City of Santa Fe, New Mexico

memo

2026-012572-HDRB. 1563 Delora Estates. Historic Review District. Infinity Builders, agent for John De Lora, owner, proposes to construct a 4,173 sq. ft. residence to a height of 22'-7", where the maximum allowable is 26'-0" on a vacant lot. An exception is requested to section 14-4.6(F)(2)(IV) for a pitched roof where one is not allowed.

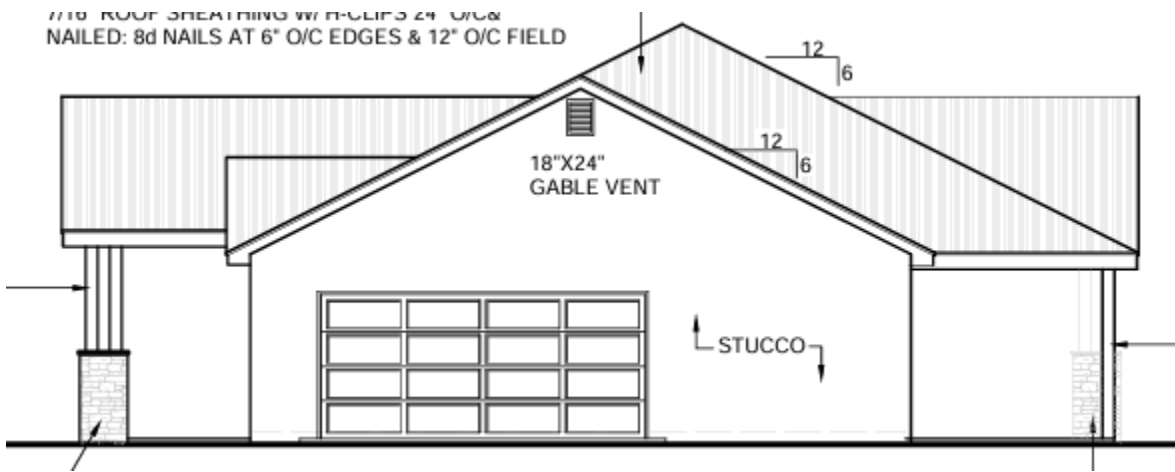
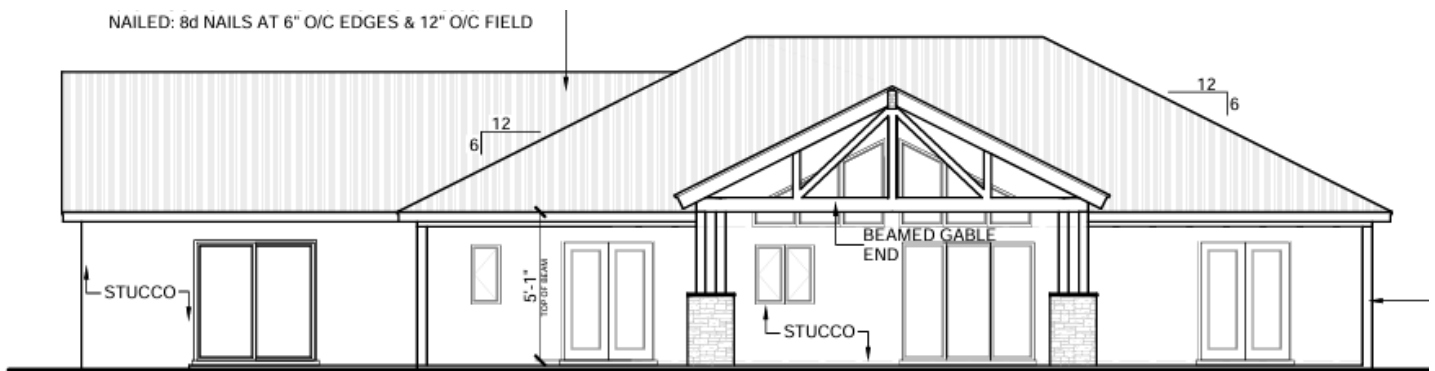
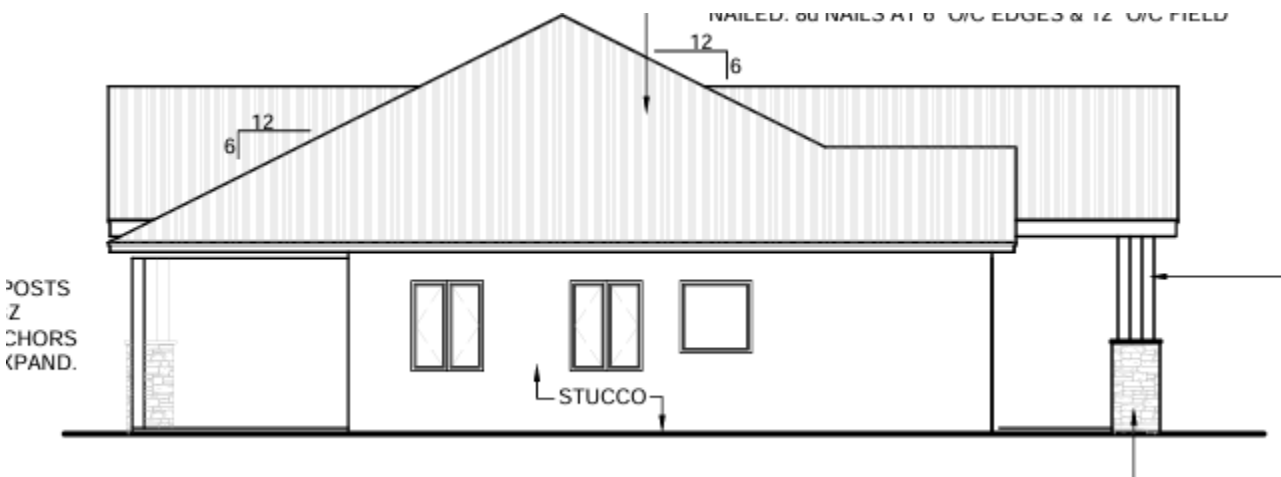
Staff finds that the exception criteria to section 14-4.6(F)(2)(IV) for a pitched roof where one is not allowed have not been met and recommends denial of the pitched roof. Staff recommends denial of the other elements of the application as they do not comply with 14-5.2(D) General Design Standards for all Historic Districts, and 14-4.6(G)(3) Historic Review Historic District Design Standards.

Staff Response: Staff find that this criterion is not met. Starting at the intersection of Wilderness View and Wilderness Gate Road and going south one-half of a mile to the intersection of Wilderness Cove and Wilderness Gate there are 20 developed properties. Of those 20 properties only two have a pitched roof. With only ten percent of the structures in a half mile of strip of road, a pitch is not standard in this development area.

Staff Response: Staff find that this criterion is not met. Flat roofed houses are constructed durably and with functional roof systems and have survived for hundreds of years as is indicative of our historic districts. It is a feasible design standard for Santa Fe and our historic districts.

Figure 7: Pitch Roofs in the development area

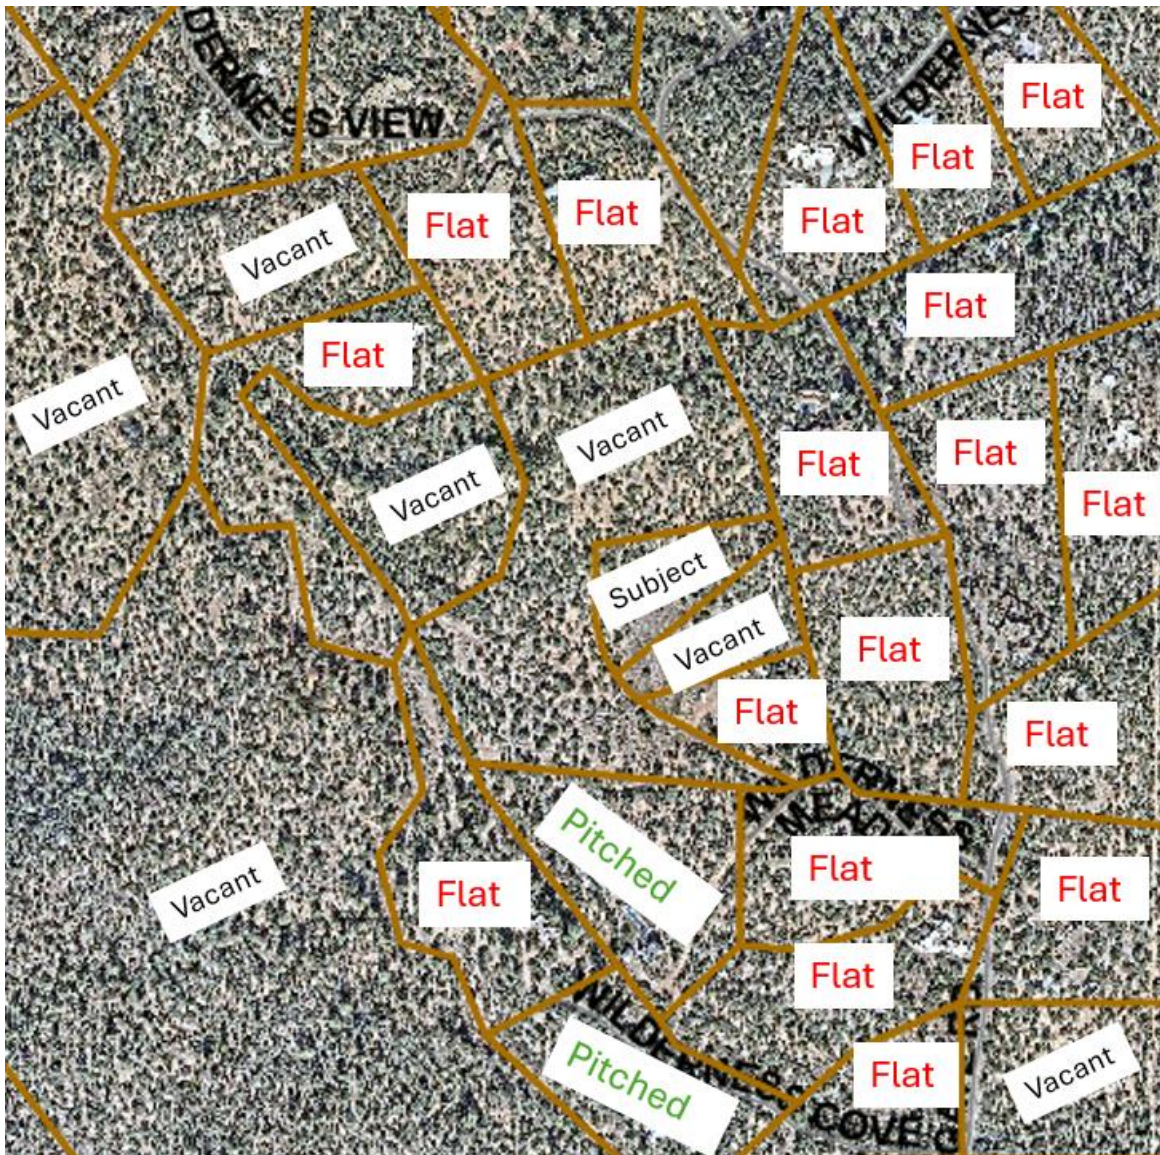
Staff Response: Staff find that this criterion is not met. Starting at the intersection of Wilderness View and Wilderness Gate Road and going south one-half of a mile to the intersection of Wilderness Cove and Wilderness Gate there are 20 developed properties. Of those 20 properties only two have a pitched roof. With only ten percent of the structures in a half mile of strip of road, a pitch is not standard in this development area. Please see Figure 7 below.
